MASSACHUSETTS INSTITUTE OF TECHNOLOGY
INVESTMENT MANAGEMENT COMPANY
One Broadway, 9th Floor, Suite 200
Cambridge, MA 02142

March 16, 2021

Re: Modifications to Volpe Site Plan / Special Permit Application (PB #368)

Figure 2

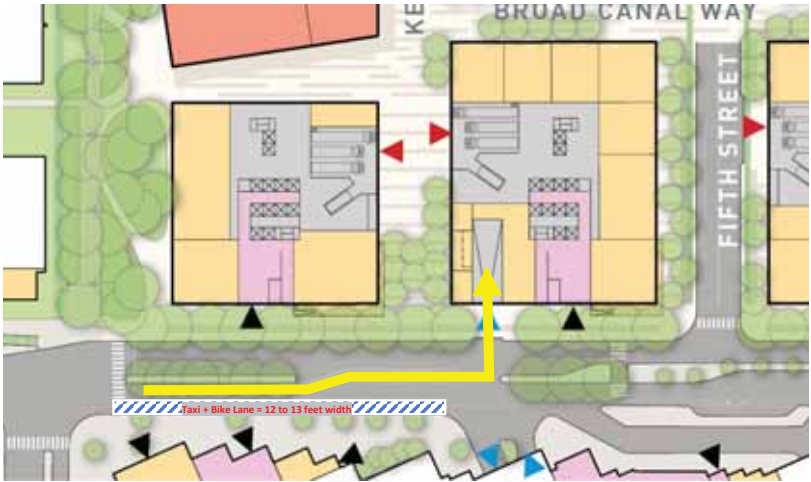
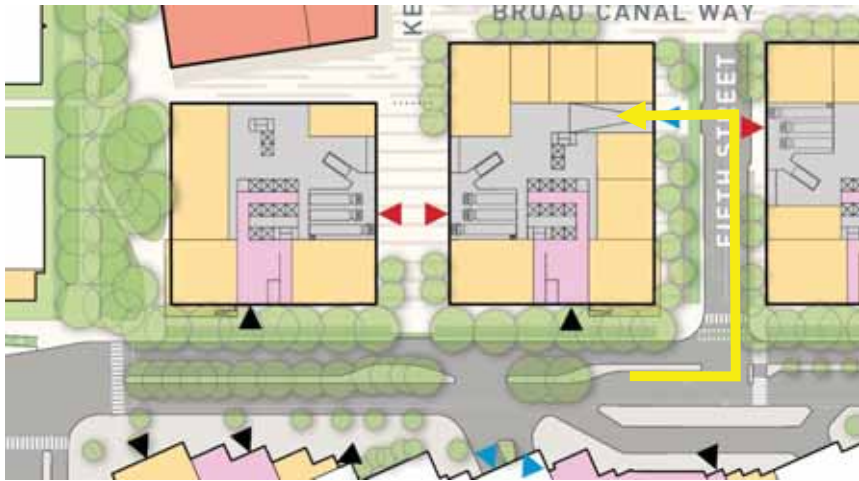
The original Site Plan proposed a left turn from Broadway directly into the garage of C2. The City was concerned about removing a section of the Broadway median, which would have required removal of four to five mature trees, and the queuing this would create. The City was also concerned about creating a potential conflict point for bikes/pedestrians along the northern sidewalk. The modified plan now shifts the left-turn into the Site to Fifth Street and relocates the C2 garage ramp to Fifth Street. This change saves the referenced mature trees and reduces the potential bike/pedestrian conflict points by removing the C2 garage ramp from Broadway. See Figure 2.

Topic: Left-Turn into C2

EB exclusive left-turn lane into C2 garage ramp, aligned with Green Garage driveway; Median island reduced.

Eastbound left-turn lane at Fifth Street intersection; New break in median island, crosswalk relocation.

Figure 3

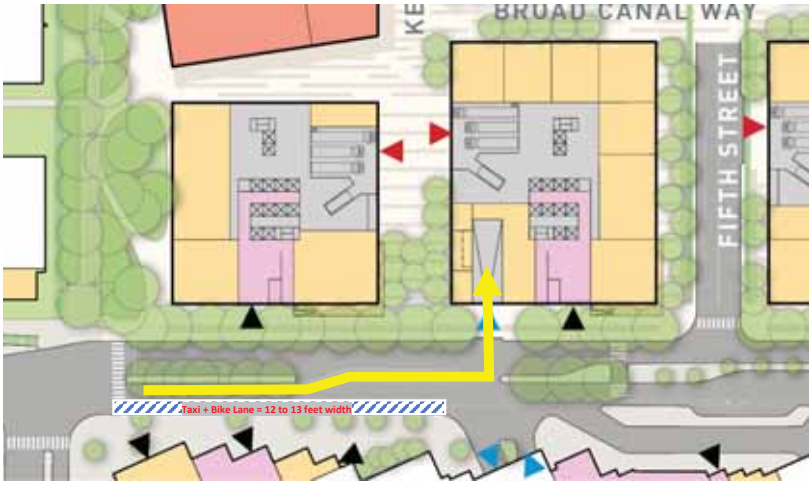
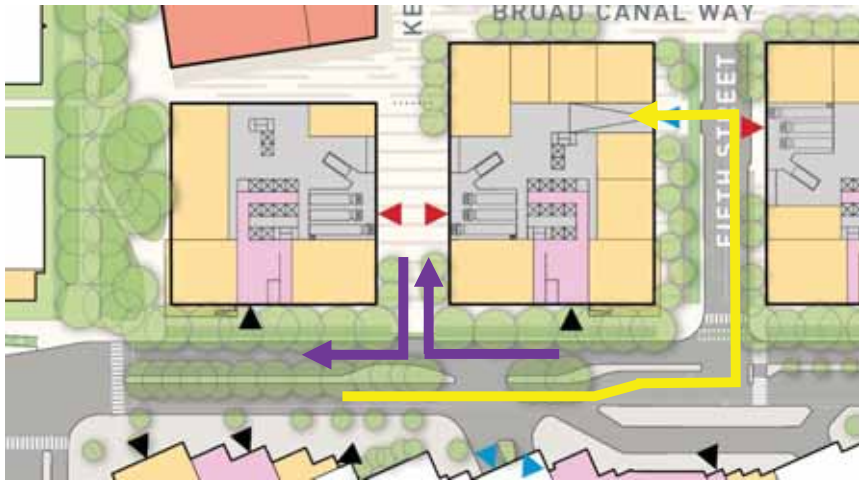
The original proposal included a pocket park at the south end of Kendall Way, thereby limiting access from Broadway to Kendall Way to only bikes and pedestrians. The City was concerned that the original plan only allowed truck access to the C2 and C3 loading docks from Potter Street, and that this would create conflicts with bikes and pedestrians both along Kendall Way and when crossing Broad Canal Way. In response, MIT has removed the Kendall Way pocket park and has introduced limited access for service vehicles by allowing right-turn to and from Broadway onto Kendall Way. This revision allows for truck activity to be dispersed, and

importantly, by providing limited access to the Site at Kendall Way, reduces the number of trucks that will travel across Broad Canal Way en route to Potter Street. This will improve the viability of Broad Canal Way as a vibrant, active shared street where people feel comfortable roaming freely, from side to side and from one retailer to another, without worrying about conflicts with service vehicles. See Figure 3.

Kendall Way connection to Broadway for peds and bikes only.

Parking ramp on Broadway.

Right-in/Right-out for trucks only at Broadway/Kendall Way Intersection.

Parking ramp on Fifth Street.

Figure 4

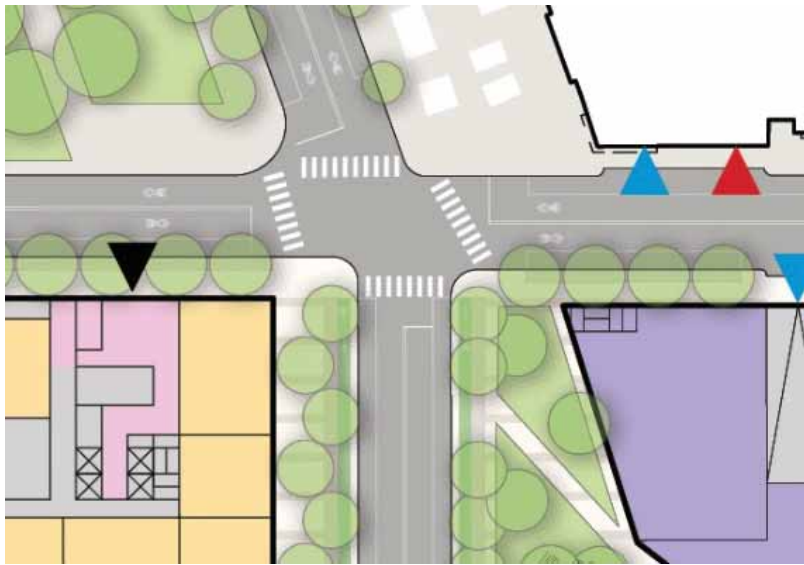
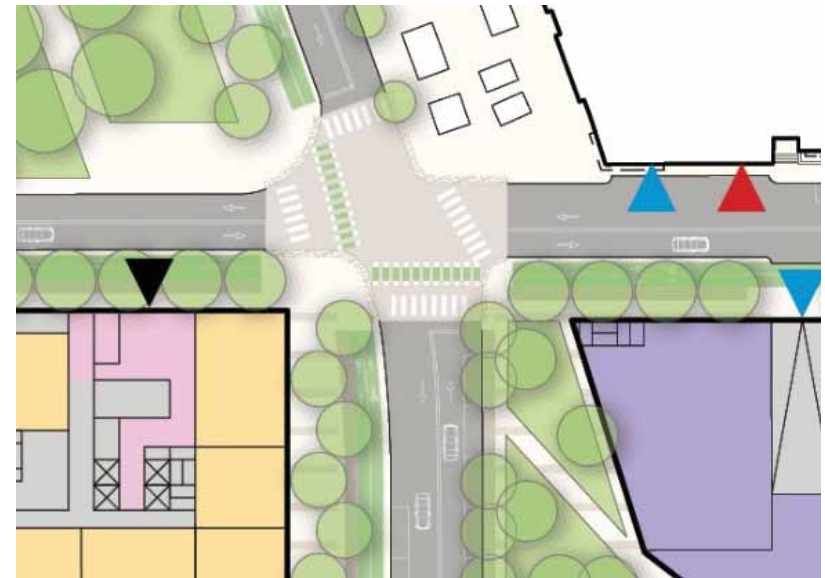
In the original Site Plan, the northern leg of Fifth Street intersected Potter Street at an angle that caused an awkward alignment through the Potter Street intersection. The City expressed concern over this alignment, particularly as it pertained to sight lines and pedestrian/bicycle visibility and safety when moving through the intersection. MIT has since revised the plan to arc the intersection at the southbound side of Fifth Street, thereby improving the awkward alignment. MIT continues to work with TP&T to identify other treatments (e.g., raised intersections or all-way stop control) that would slow vehicle speeds and improve this intersection further. These changes will greatly improve bicycle and pedestrian safety at this intersection. See Figure 4.

Fifth Street misalignment. Pedestrian/Bicycle crossings not visible at the intersection.

Introducing an arc / curve to Fifth Street south leg. Raised intersection treatment and all-way stop control for higher visibility of pedestrians and bicyclists and to slow down vehicles.

Figure 5

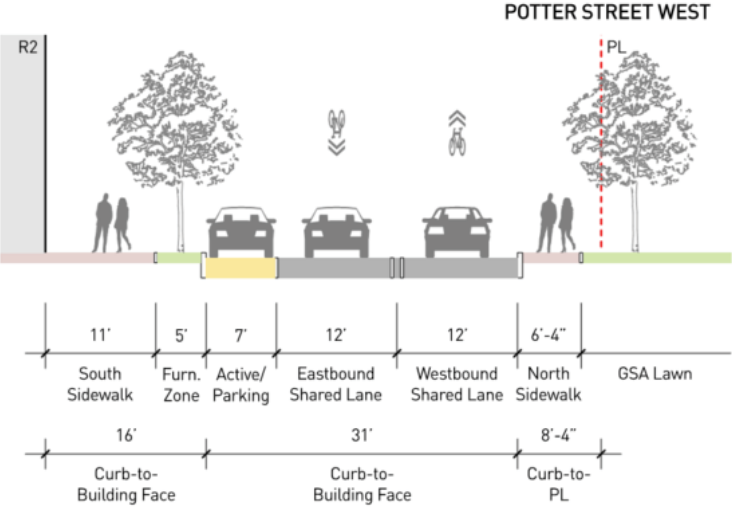
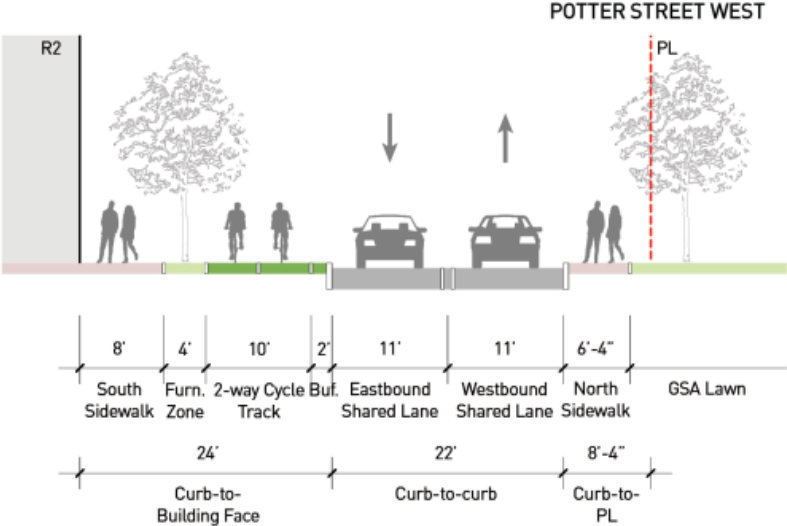
The baseline plan as submitted contemplated a shared lane for vehicle/bicycle use along Potter Street. Based on feedback from City Staff, and in response to specific concerns from the City's Bicycle Committee and Pedestrian Committee, MIT has revised the plan to include a two-way cycle track on Potter Street. This is a significant improvement and will make Potter Street a safer and highly desirable route for those traveling east-west, from Third Street to the Kittie Knox Bike Path and beyond. This change also eliminates potential conflicts between bikes and trucks, as Potter Street will be used by service vehicles entering the new Volpe Transportation Center (the GSA site). This change aligns with the 2015 Cambridge Bicycle Plan that shows Potter as a secondary route. See Figure 5.

Potter Street with sharrows

Potter Street with two-way cycle track

Figure 6

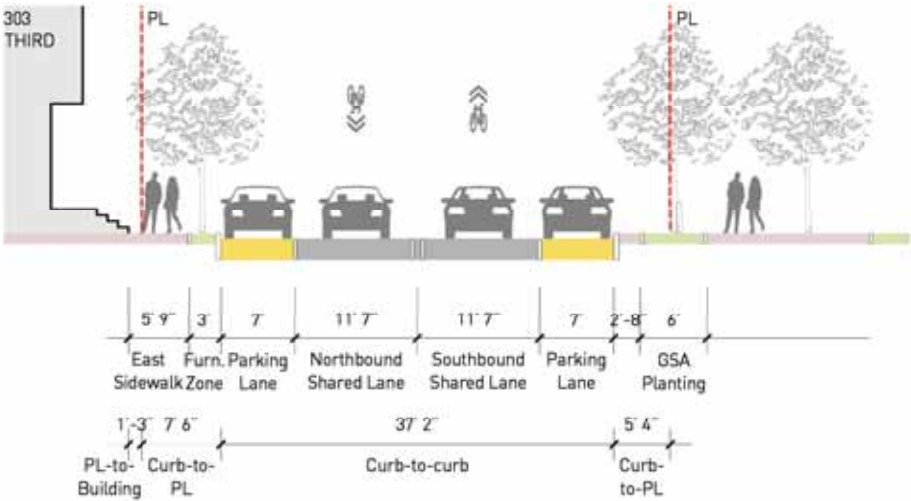
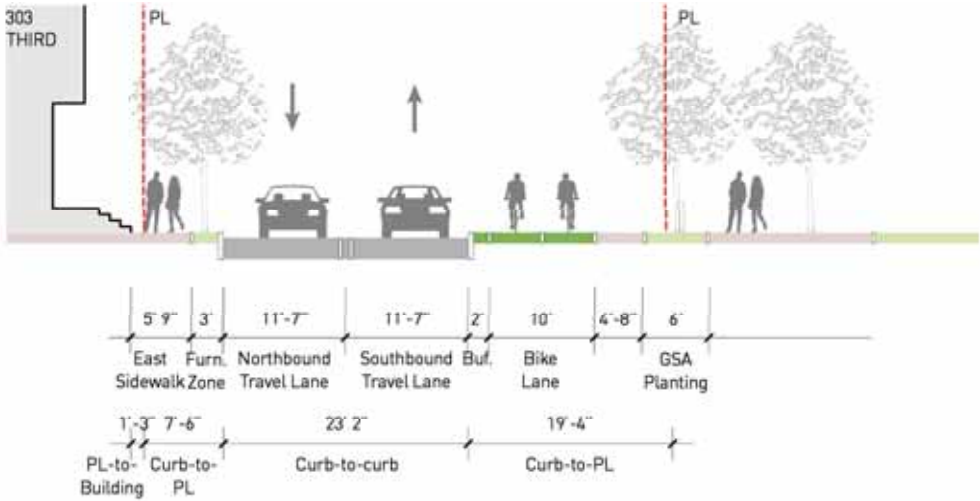
The baseline plan contemplated two, one-way cycle tracks on Fifth Street between Broadway and Potter. The remainder of the street, between Potter Street and Binney Street, was presented with only sharrows (shared lanes between vehicles and cyclists). Both the City and the Bike/Pedestrian Committee expressed concerns over this design, and in response, MIT has created a revised plan that shifts the sidewalks along the westerly line of Fifth Street to create the space necessary to provide a two-way cycle track along the entire stretch of Fifth Street from Binney to Broadway. This shift also eliminates on-street parking currently situated along the easterly sideline of Fifth Street. This creates a safe north-south connection for cyclists coming to and moving through the site. Moreover, this change creates a seamless route for those looking to safely get to and from the Kendall Square MBTA station and further promotes Volpe as a multi-modal destination. We understand that this portion of Fifth Street is subject to the rights of other private parties, and we note that implementing the revised plan may be subject to the approval of such other parties, as necessary. See Figure 6.

Fifth Street with sharrows

Fifth Street with two-way cycle track

Figure 7

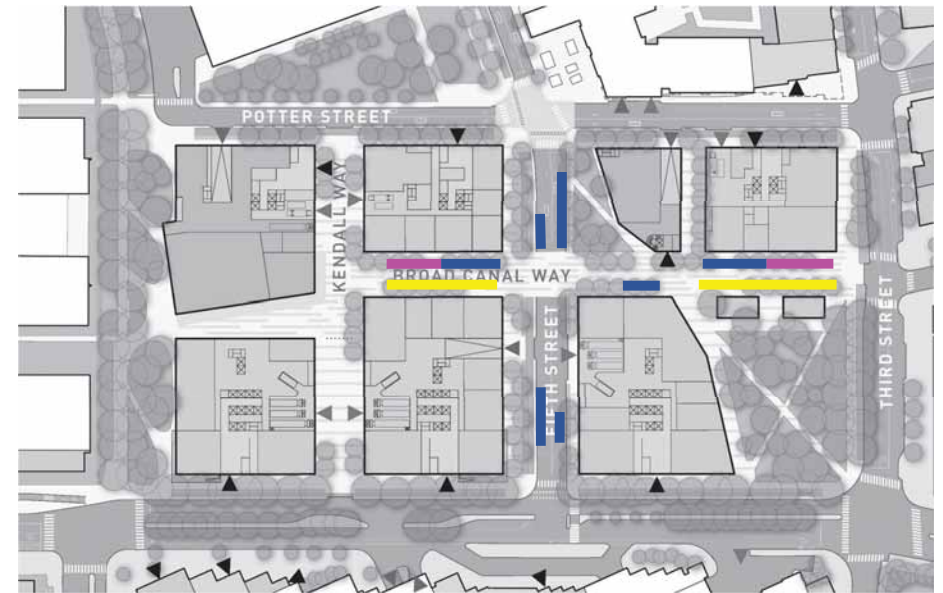
The City and the Bicycle and Pedestrian Committees expressed concern over the amount and location of on-street parking originally proposed, particularly along Broad Canal Way. MIT has since revised the site plan to reduce the amount of on-street parking. Importantly, the new plan identifies these spaces as “active curb” and “short-term loading” spaces – not simply “parking” spaces. These spaces are anticipated to be utilized by many different user groups, including those needing handicap-accessible parking, ride hailing services, delivery drivers such as “Uber Eats” vehicles, and others in need of short-term parking for other purposes. These spaces will create an “active zone” as opposed to traditional on-street parking, and will provide more inclusive access to the site for all users. See Figure 7.

55 spaces for on-street parking
27 spaces for active curb
= 82 total street spaces

6 spaces for on-street parking
22 spaces for short term loading
13 spaces for active curb
= 41 total street spaces
